ADDENDUM No. 01

Coaldale Government Building

Project No.: 9030

Project:	Coaldale Protective Services Building	File No.	841-004
Client:	Stephens Kozak – ACI Architects and Planners	Addendum No.	S1
Copy:		Date:	February 12, 2019

DRG. TITLE : **REVISED COLUMN DIMENSIONS AT GL 12/F**

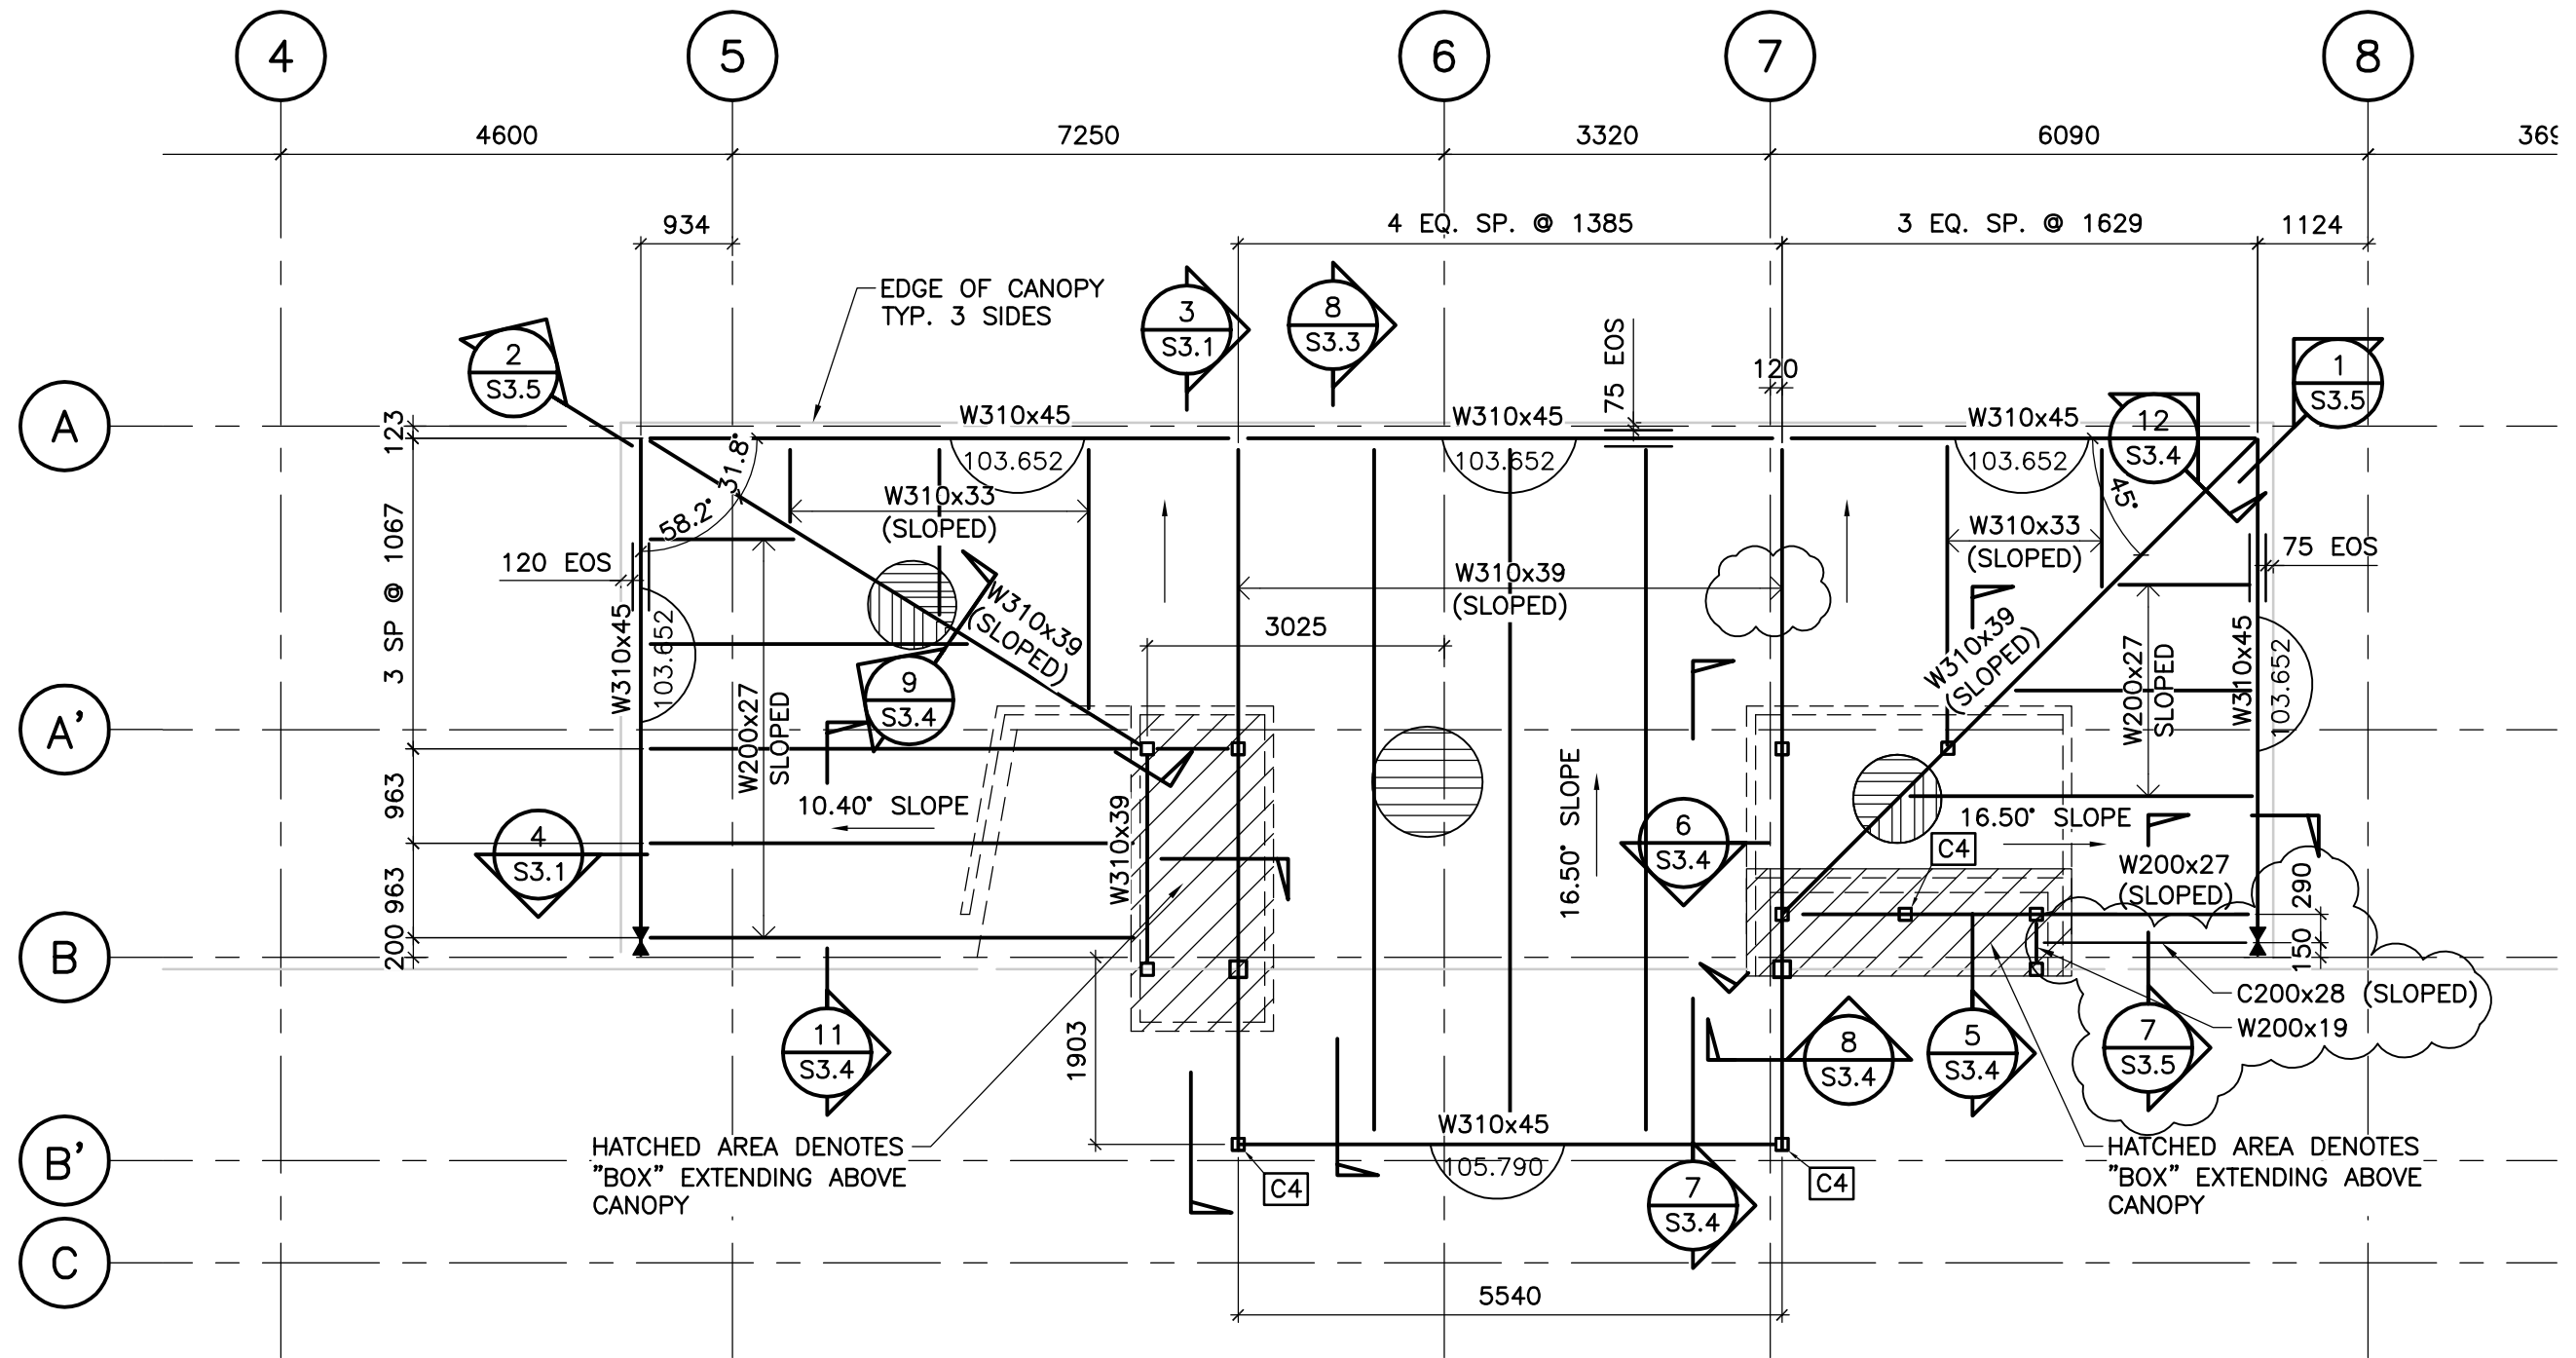
.3.1 Revise dimension of column locations along gridline 12 between gridlines F and G as clouded on SSK-001

PROJECT: STEPHENS KOZAK ACI ARCHITECTS COALDALE PROTECTIVE SERVICES BUILDING			
DRG. TITLE: NORTH CANOPY UPPER FRAMING PLAN			
DRAWN: NM	DATE: FEB. 12, 2019	FILE No.: 841-004	SKETCH No.: SSK-002

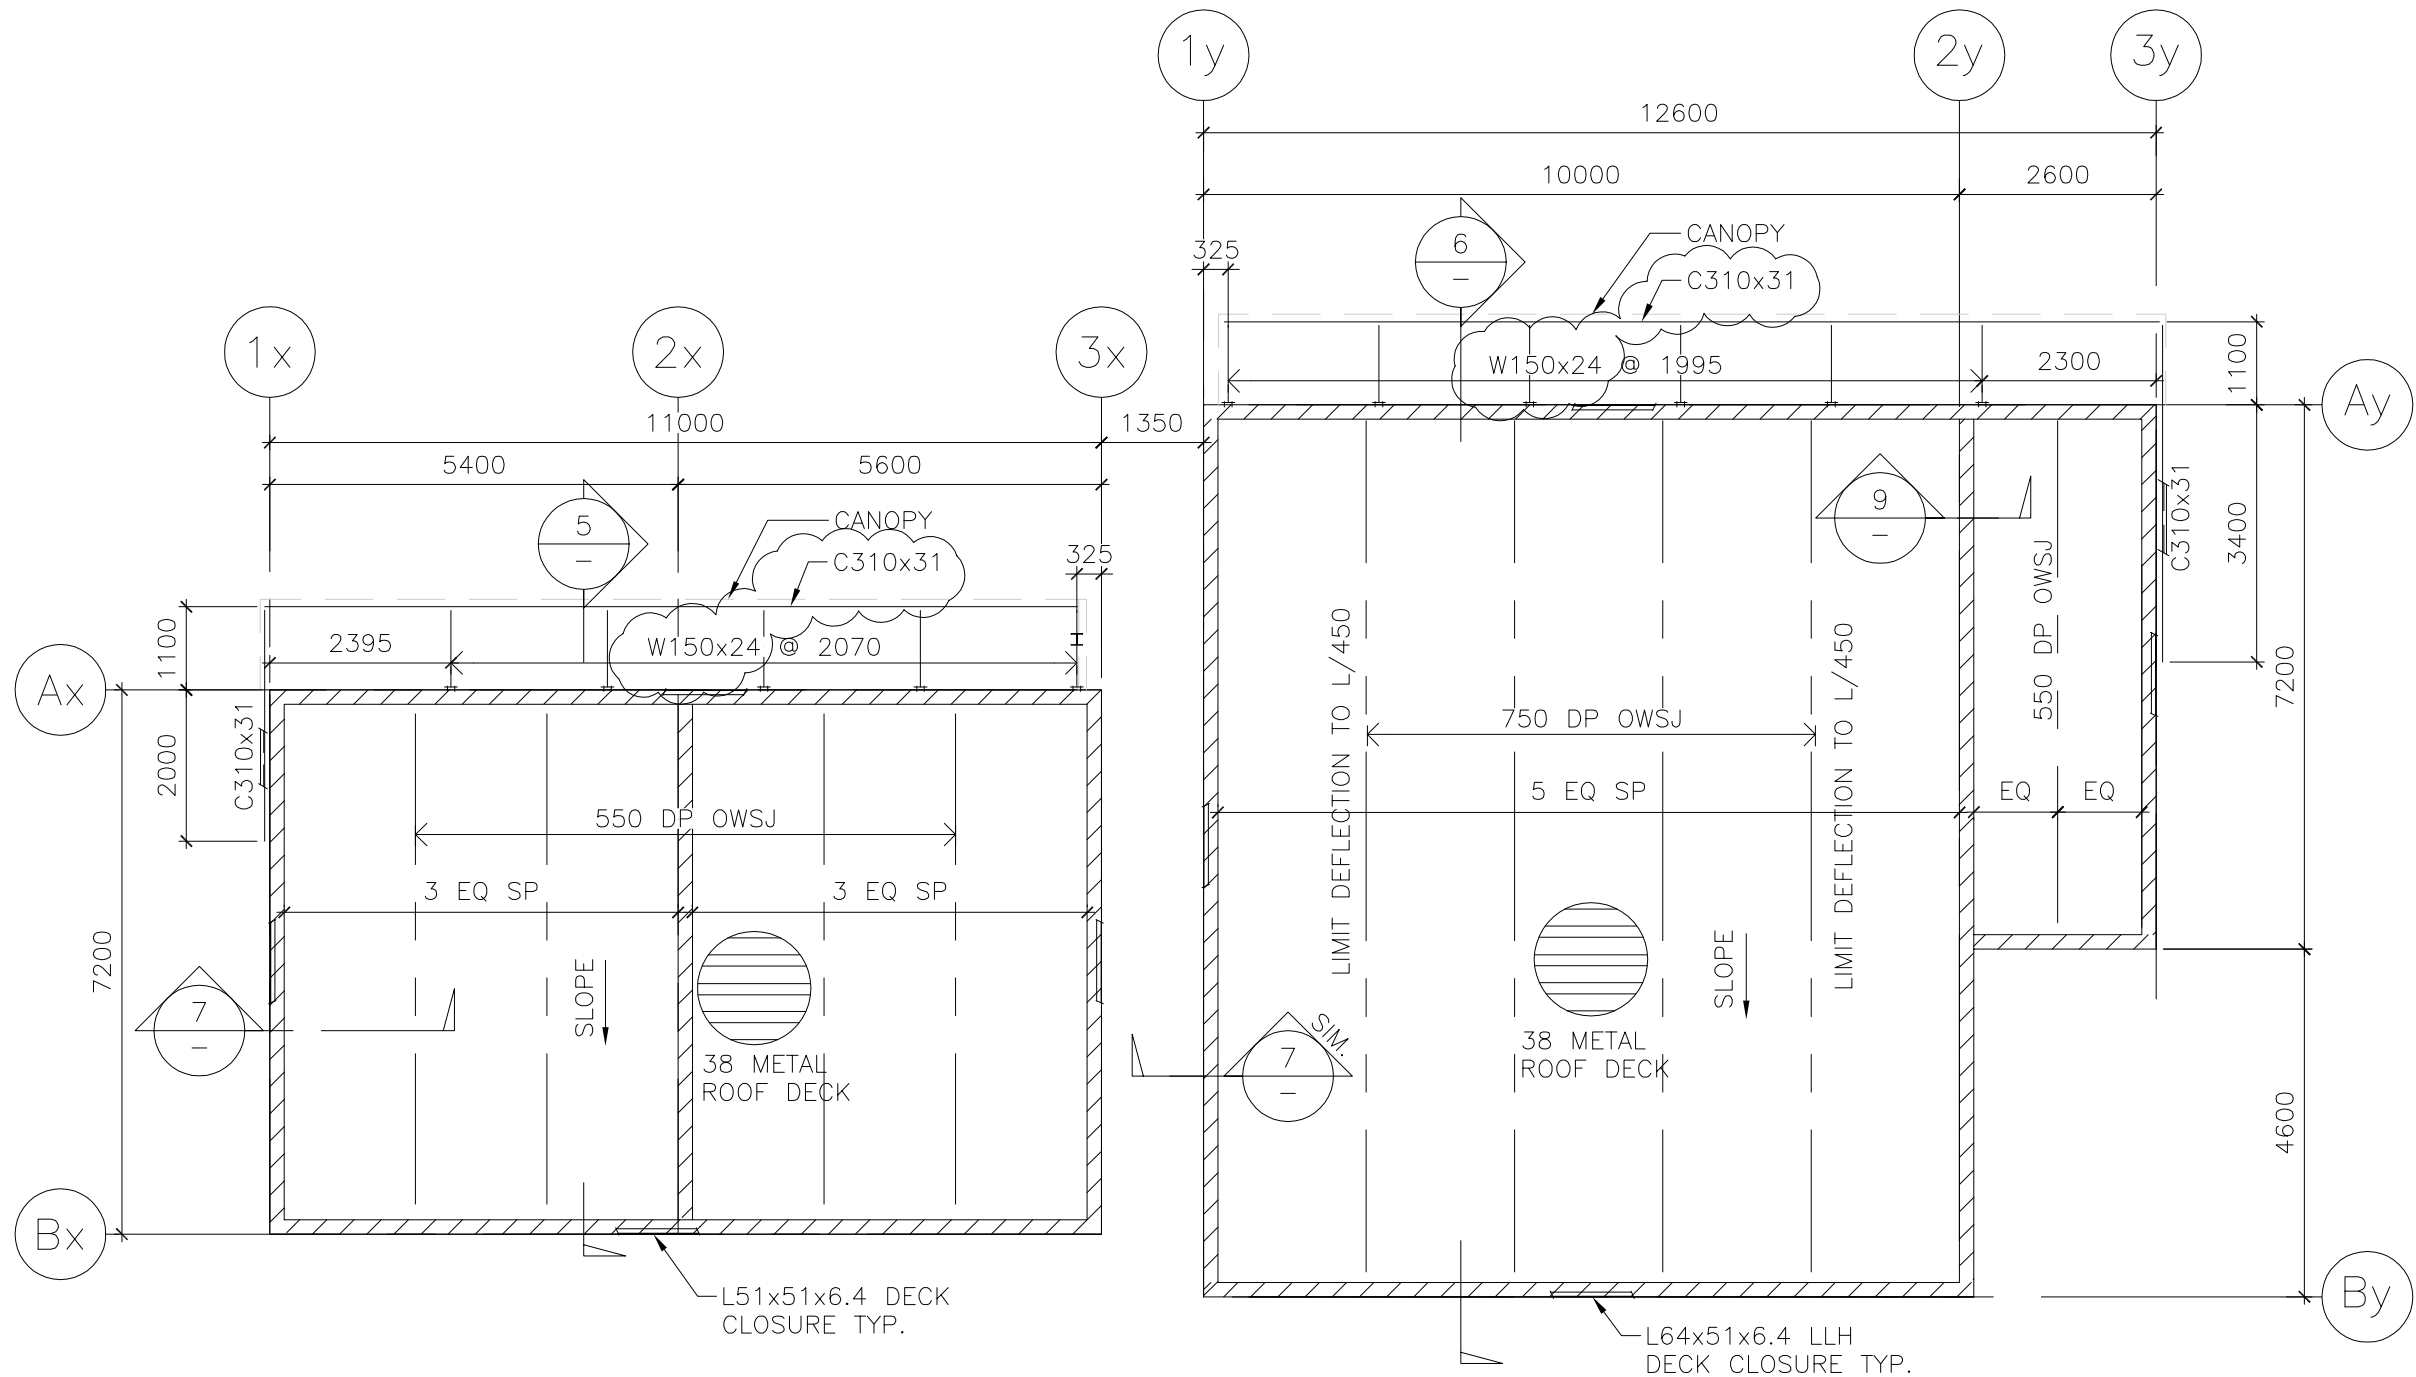
.6.1 On North Canopy Upper Framing Plan' extend arrow of W310x39 (Sloped) 120 east of gridline 7 as clouded on SSK-002.

.6.2 On North Canopy Upper Framing Plan add new section mark 7/S3.5 as clouded on SSK-002.

.6.3 On North Canopy Upper Framing Plan revise beam W200x27 (north-south) to read W200x19 near gridline B between gridlines 7 and 8 and revised W200x19 (east-west) to read 'C200x28 (Sloped)' and revise dimension as clouded on SSK-002.

Suite 200, 4220-98 Street NW Edmonton, AB T6E 6A1	(780) 436-5376 www.bptec.ca		PROJECT : STEPHENS KOZAK ACI ARCHITECTS COALDALE PROTECTIVE SERVICES BUILDING	
	DRAWN : NM		DRG. TITLE : OUTBUILDING ROOF FRAMING PLAN	
DATE : FEB. 12, 2019		FILE No. : 841-004		SKETCH No. : SSK-003

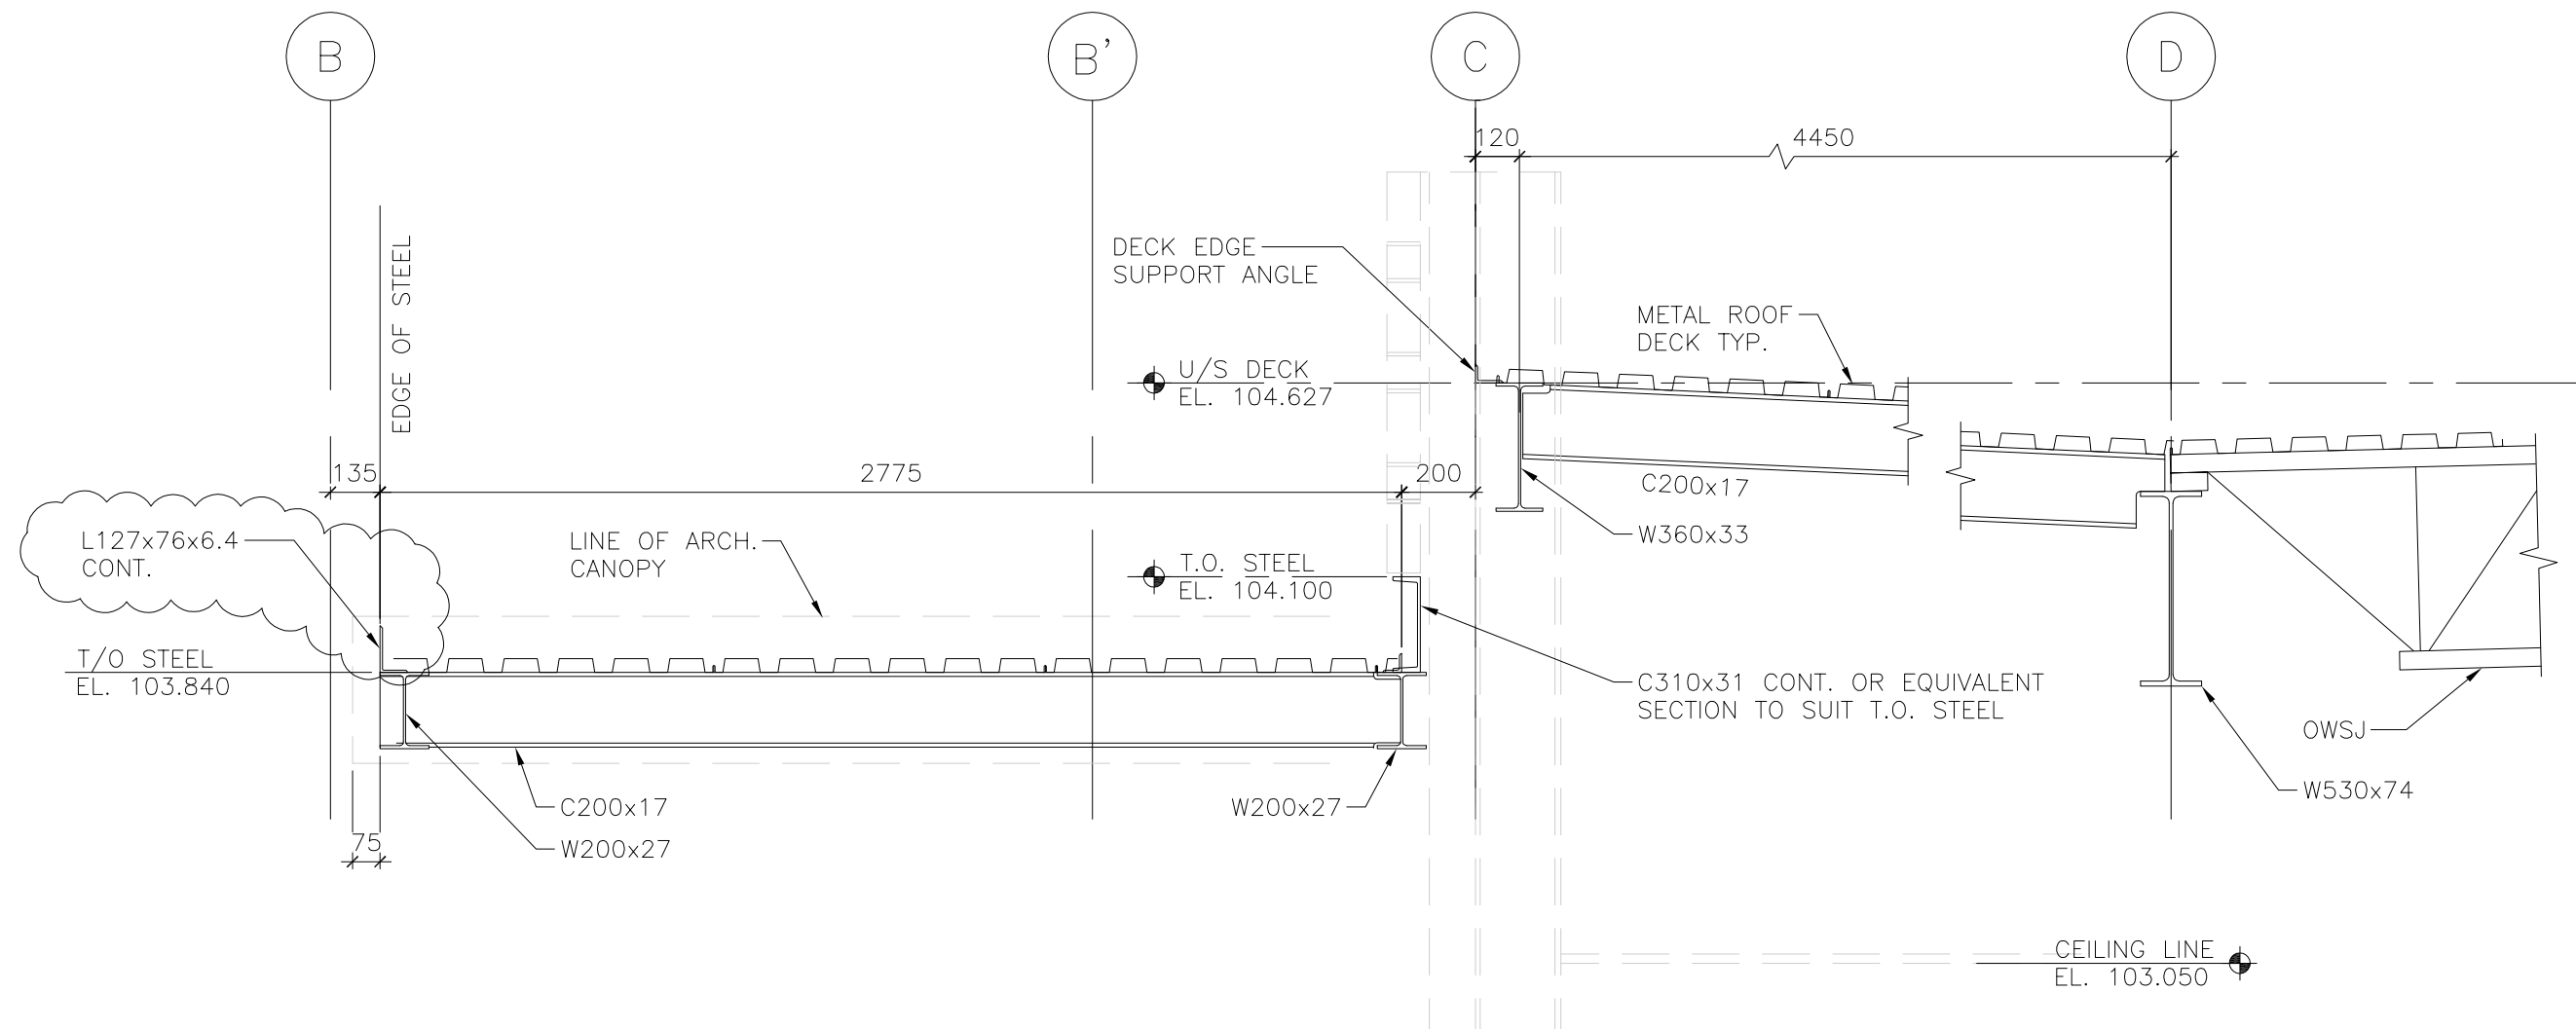
- .6.11 Add moment connection symbol (Fabreeka) on C200x17 at gridline A/9.
- .7 Drawing S1.7 Outbuilding Plans, Sections and Details**
- .7.1 On 'Outbuilding Roof Framing Plan' revise W150x22 to read W150x24 as clouded on SSK-003.

- .7.2 On 'Outbuilding Roof Framing Plan' revise C310 to read C310x31 as clouded on SSK-003.
- .7.3 On Section 5 and Section 6, add elevation mark to underside of canopy beam W150x24 to read U/S STEEL EL. 103.640.
